Groundwater and Wastewater Services File Imaging Project

INDIVIDUAL WATER AND WASTEWATER SYSTEMS PROGRAM
APPLICATION FOR SERVICES

File 7024A 4005 CRY

STREET ADDRESS: 19701 Shearwater Pt. Drive

PROPOSED PLOT PLAN

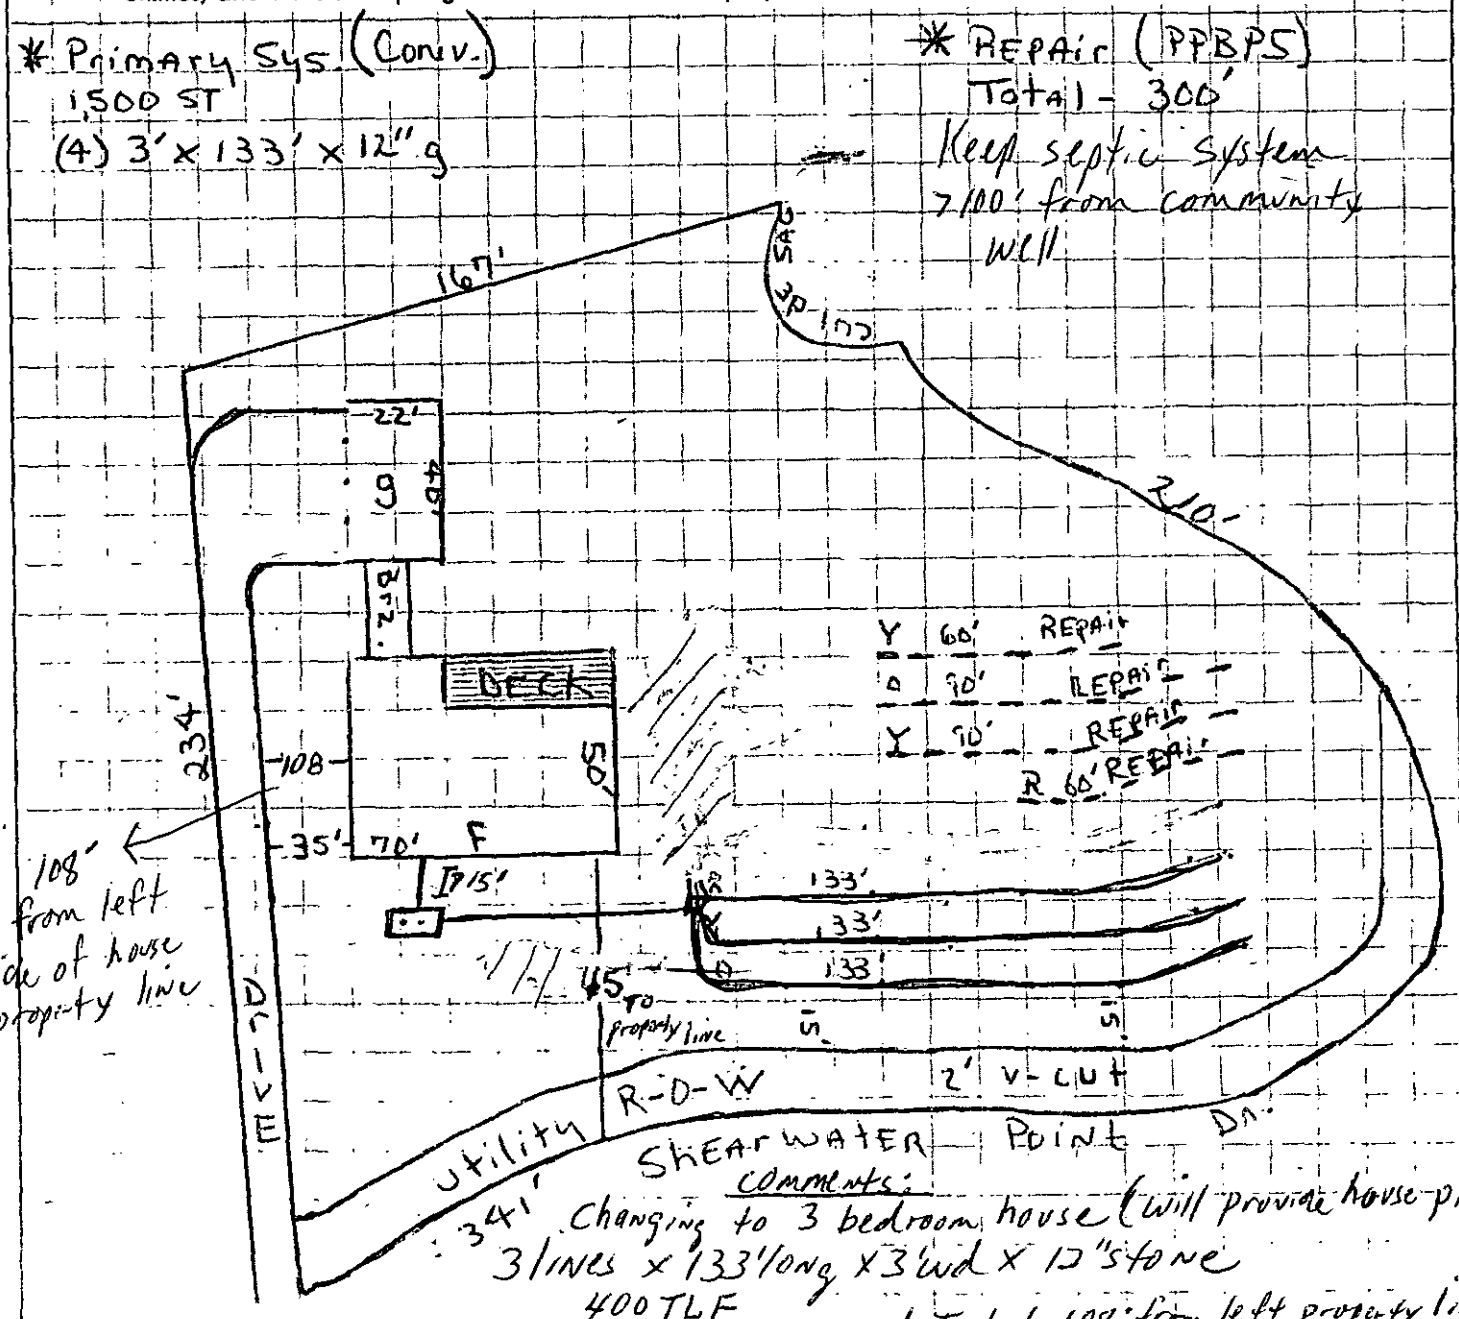
Comments:
Changing to 3 bedroom house (will provide house plan)
3 lines x 133' long x 3' wd x 12" stone
400 TLF
Adding basement moving house over 20' (Total 108' from left property line)
may need lift station. Met Craig Roseman (builder) and L. Hawkins on site 2/22/94 for proposed changes

Approval to be granted for 3 bedroom reduction after house plans submitted. RSW 2/22/94

MECKLENBURG COUNTY HEALTH DEPARTMENT
SITE EVALUATION REPORT
SERIAL NUMBER 16701

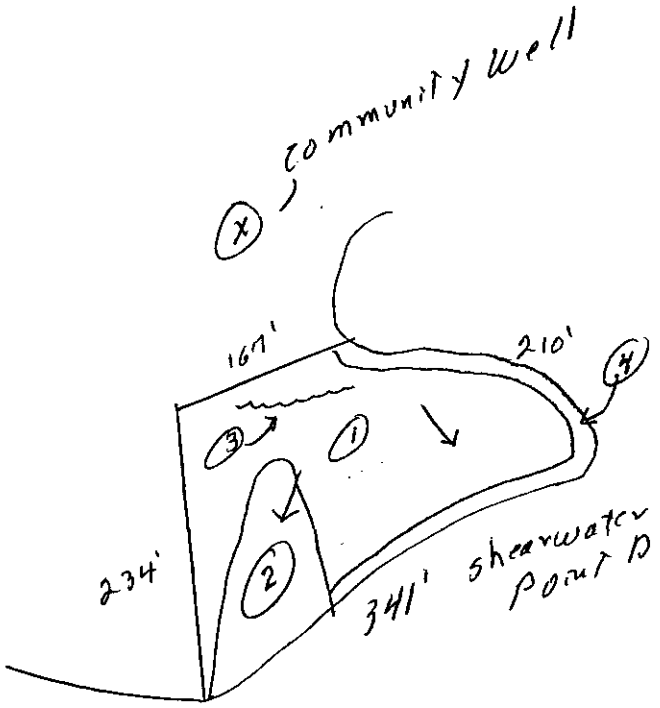
Comments: 100% Repair

FACTORS	AREA 1	AREA 2	AREA 3	AREA 4	AREA 5	AREA 6
Topography	(S) PS U 2-8%	S PS U —	S PS (U) complex slopes	S PS (U) >2' cut	S PS U	S PS U
Texture	S (PS) U clay	S PS U —	S PS U —	S PS U —	S PS U	S PS U
Structure	S (PS) U Blocky	S PS (U) compacted Fill	S PS U —	S PS U —	S PS U	S PS U
Drainage	S (PS) U >30" TO water	S PS U —	S PS U —	S PS U —	S PS U	S PS U
Depth	S (PS) U 40"+	S PS U —	S PS U —	S PS U —	S PS U	S PS U
Restrictive Horizons	S (PS) U >40"	S PS U —	S PS U —	S PS U —	S PS U	S PS U
Available Space	S PS (U) Acceptable	S PS U —	S PS U —	S PS U —	S PS U	S PS U
Other (specify)	S PS U	S PS U	S PS U	S PS U	S PS U	S PS U
Soil Group/Series	IV cecil-1.4%	compacted Fill	complex slopes	>2' cut		
Area Classification	S PS (U)	S PS (U)	S PS (U)	S PS (U)	S PS U	S PS U
